AMENDMENTS TO THE DRAWINGS

REMARKS

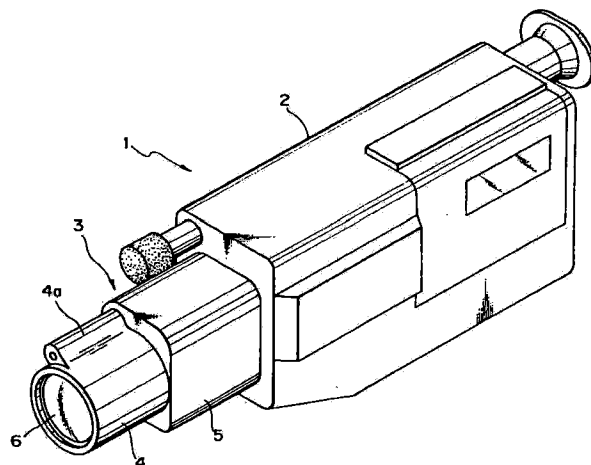
The rejection statement asserts that *Inoue* discloses “a lens position detecting device for detecting the position of a lens (10) on a base (18) in an optical system . . . the base being fixedly mounted in a lens barrel body.” *Final Office Action* at 5. As illustrated in FIG. 6 and recited by *Inoue*, the rear wall 18, which the rejection statement equates to the claimed “base,” is not a separate component from the lens barrel body, but rather, a portion of the rear side outer shell 5, *i.e.*, **a portion of the lens barrel body**. The rejection statement asserts that “a magnetic force detecting sensor (41) [is] mounted on said base [18].” *Final Office Action* at 5. However, the Hall effect element 41, which the rejection statement equates to the claimed magnetic force detecting sensor, is mounted in a “mounting recess 18b formed at a left lower portion of the rear wall 18 of the rear side outer shell 5.” *Inoue* at col. 7, ll. 54-56. Because the rear side outer shell 5 is a portion of the **lens barrel body**. That is, the Hall effect element 41 is mounted directly on the **lens barrel body**, the Hall effect element 41 is **not** mounted a “base being fixedly mounted in a lens barrel body,” as required by independent claim 1. Specifically, the Hall effect element 41 is mounted directly to an inner surface of a lens barrel body without first being mounted to a base which is fixedly mounted to the lens barrel body.

Inoue Figure 3

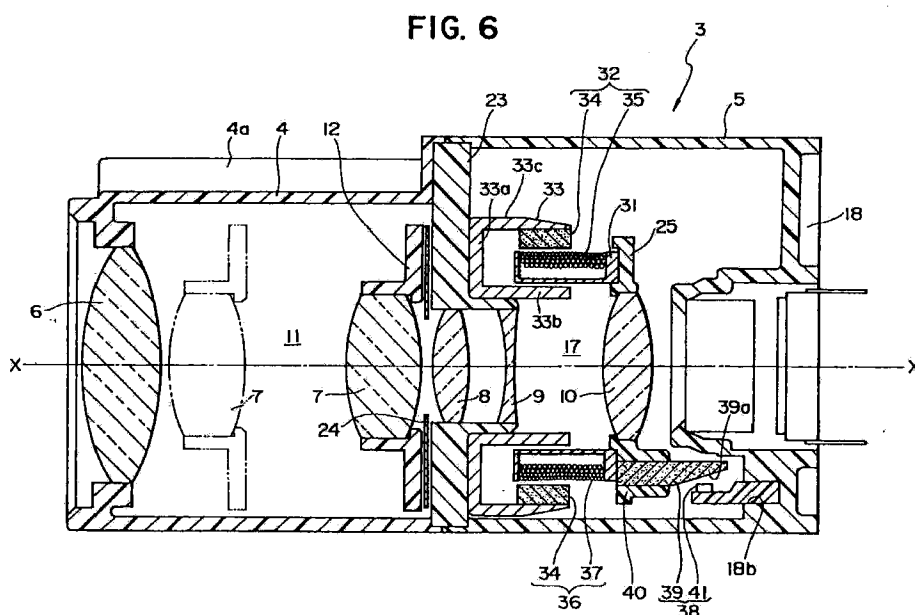
Inoue is directed to a lens barrel apparatus for a camera having an automatic focusing function. As illustrated in FIG. 3 of *Inoue* reproduced below, *Inoue* discloses a barrel apparatus 3 including a front side outer shell 4 coupled to a rear side outer shell 5

that extends from a front face of the body 2 of the camera 1. *Inoue* at col. 3, ll. 62-68--
 col. 4, ll. 1-5.
